**PZ&B Staff Combination Memorandum: Landmarks Preservation Commission and Town Council**

**SUBJECT:** ZON-24-0022 (HSB-24-0003) 346 SEASPRAY AVENUE (COMBO)

**MEETING:** JULY 17, 2024, LPC  
AUGUST 12, 2024, TC

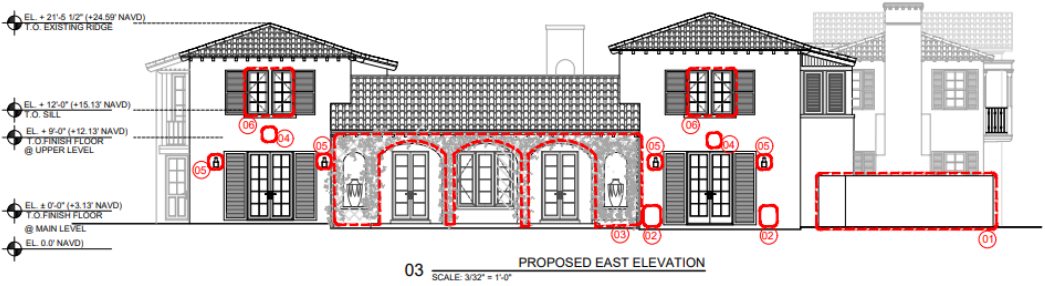
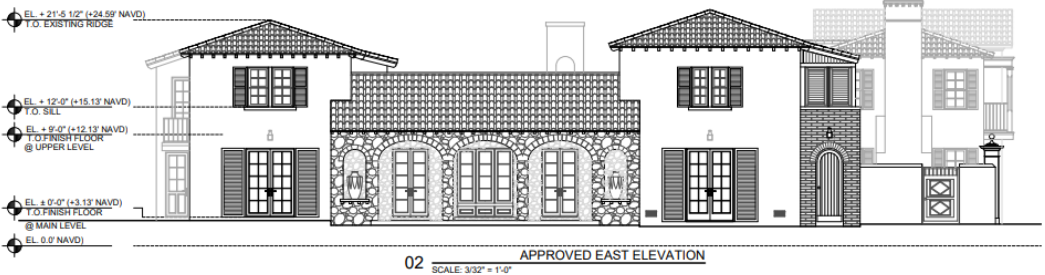
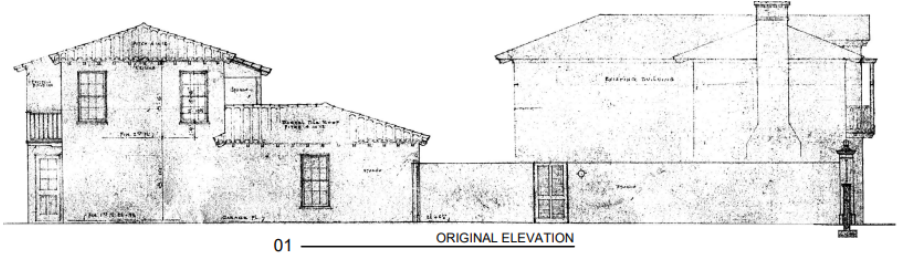
On the north elevation (fronting Seaspray Ave), removal and relocation of light fixtures, shutter removal, redesign of railings, changes to exterior finishes to smooth stucco in locations where masonry was previously approved, and a new exterior door is proposed. From a historic preservation perspective, maintaining a smooth stucco exterior finish is appropriate based on the original architectural plans. In addition, the removal of the second-story loggia shutters is also acceptable since they are not original features. However, staff has concerns regarding the design of the new door and railings. The design of the doors, similar to the new gates, is not compatible with the architectural style of the building. Both the new exterior door and railings present a valuable opportunity to reconstitute original design features. Staff recommends further study of these features.

use of double hung windows is a better option for consistency with the original plans. The use of casement windows can be mitigated with divided-light patterns that replicate the appearance of sash windows with a wider (central) horizontal muntin.

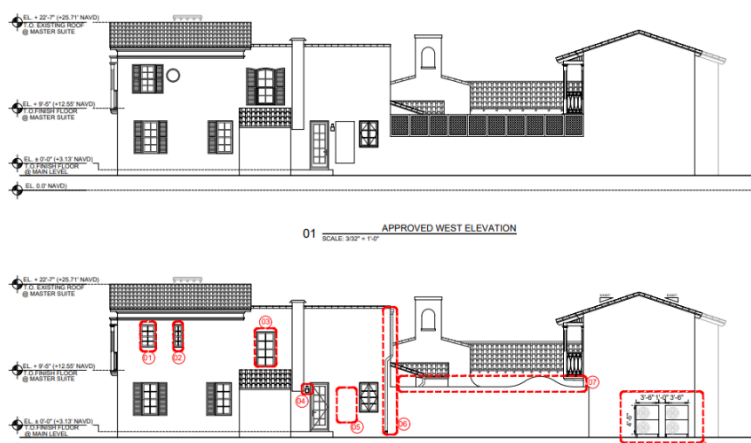
On the south elevation, mechanical equipment was removed, windows were removed and added, a new pair of French doors was proposed, light fixtures were added and relocated, shutters were removed, an overhang was removed, a new second-story trellis was added to an existing balcony, and changes to exterior finishes to smooth stucco in locations where masonry was previously approved are proposed. As previously discussed, the removal of shutters and the smooth stucco exterior finish is consistent with the original plans. Staff has concerns related to removing or relocating original openings and the use of casement windows instead of hung windows. However, changes to rear facades can be given greater flexibility due to their low level of visibility.

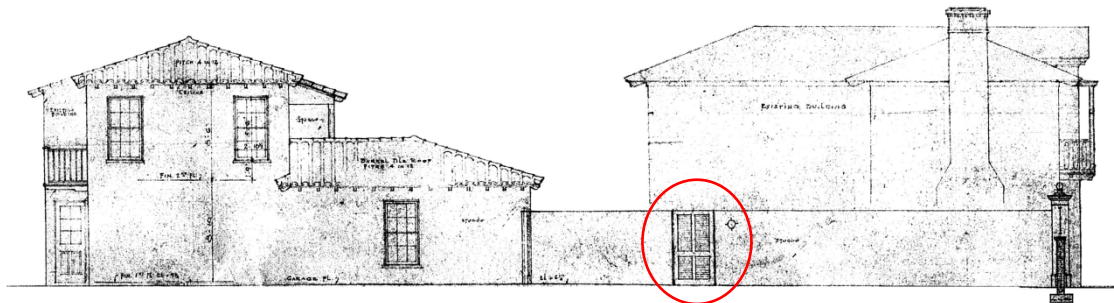
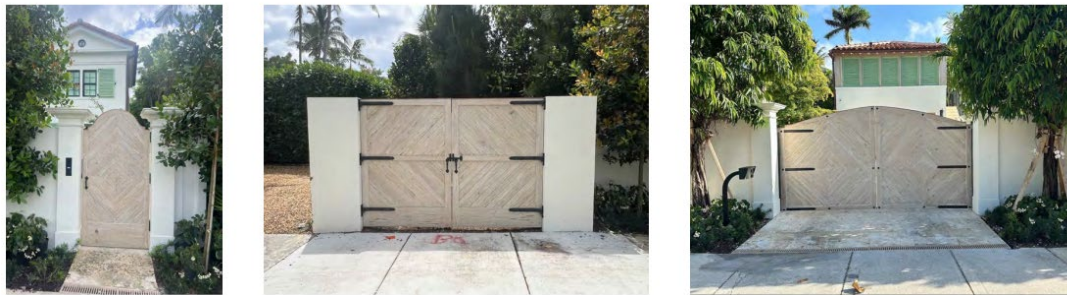
The proposal seeks to revise the design of the vehicular and pedestrian gates on the property. The gates feature diagonal wood planks. Staff has concerns that the design of the gates is not compatible with the HSB structure. The best design approach would be to replicate or seek inspiration from the gate designs in the original architectural plans.

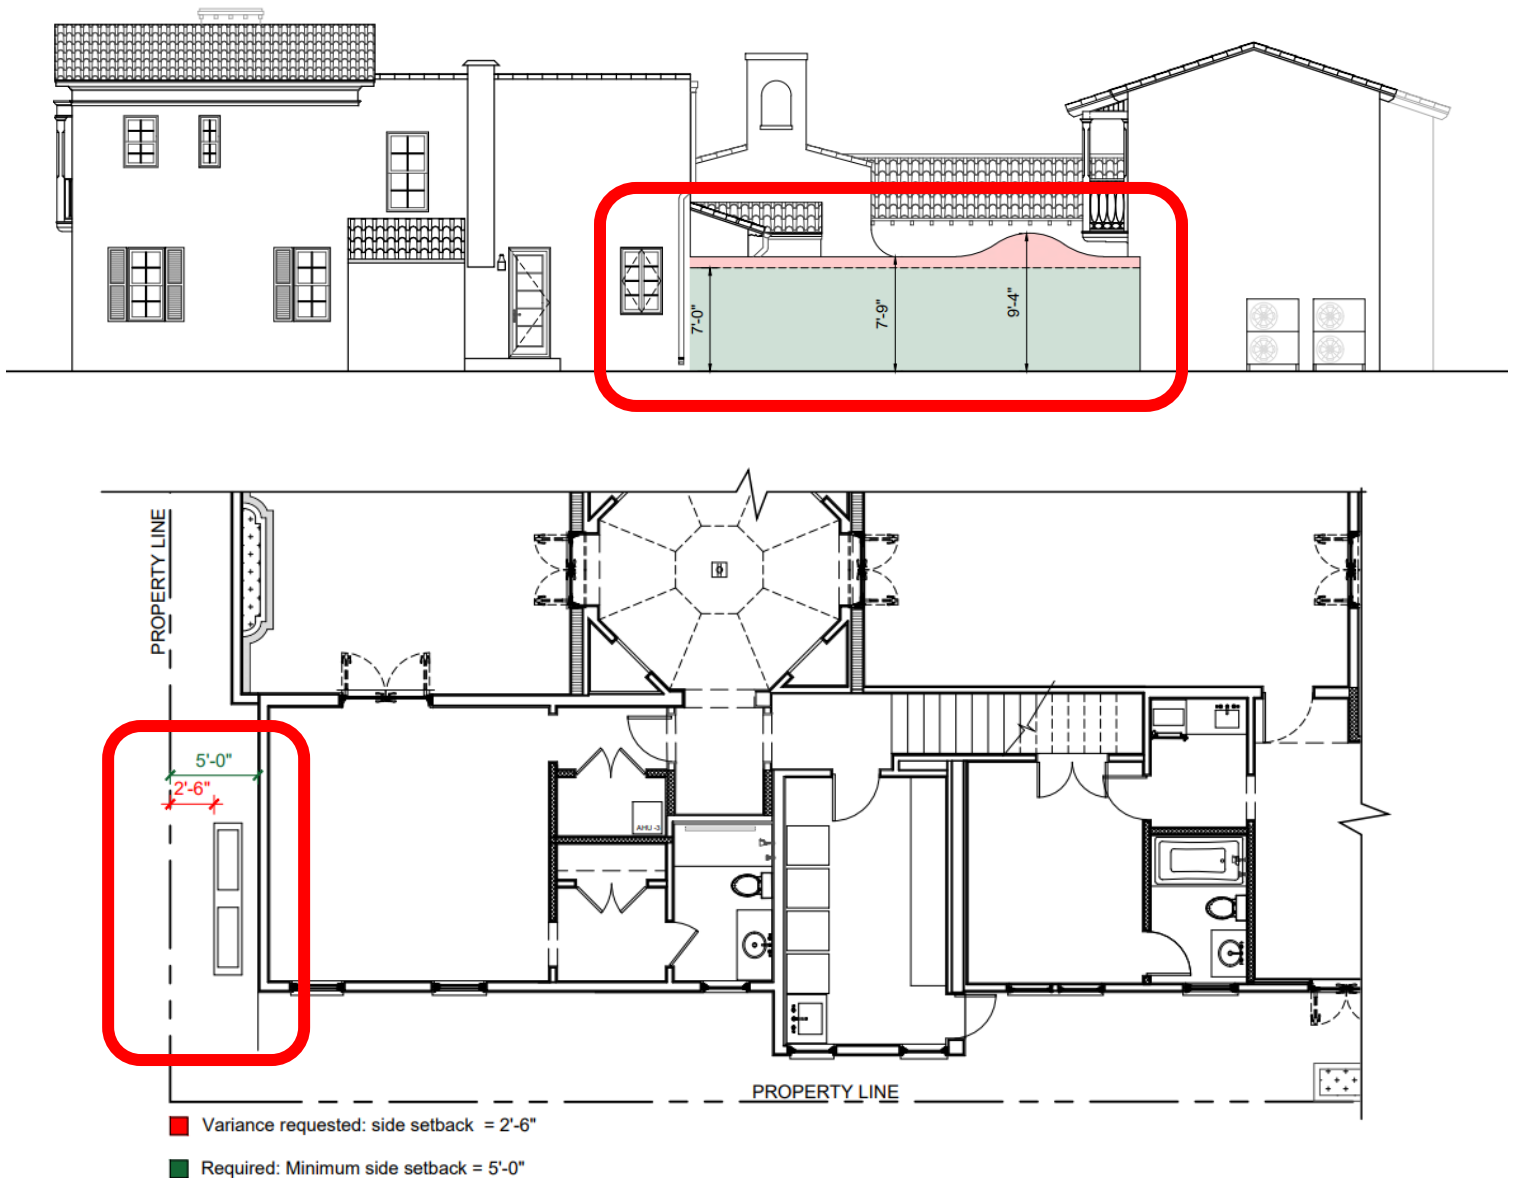
Code Section	Required	Proposed	Variance
<b>Variance #1:</b> Sec. 134-1728(a)	5'-0" Mechanical Equipment Side Yard Setback	2'-6" Mechanical Equipment Side Yard Setback	2'-6"
<b>Variance #2:</b> Sec. 134-1669	7'-0" Side Yard Site Wall Height	9'-4" Side Yard Site Wall Height	2'-4"

As explained by the applicant in the letter of intent, additional wall height is requested to replace the privacy that was offered by the lattice. Furthermore, the applicant contends that there is no other feasible location for the mechanical equipment other than where it is proposed within the side yard setback. Staff has concerns that the work was already completed without approvals or variances. In addition, the subject property is much larger than the typical R-B zoned lot. There are likely several solutions that would avoid the need for variances by considering other locations for the mechanical equipment and using landscaping to achieve greater privacy where additional wall height is desired.
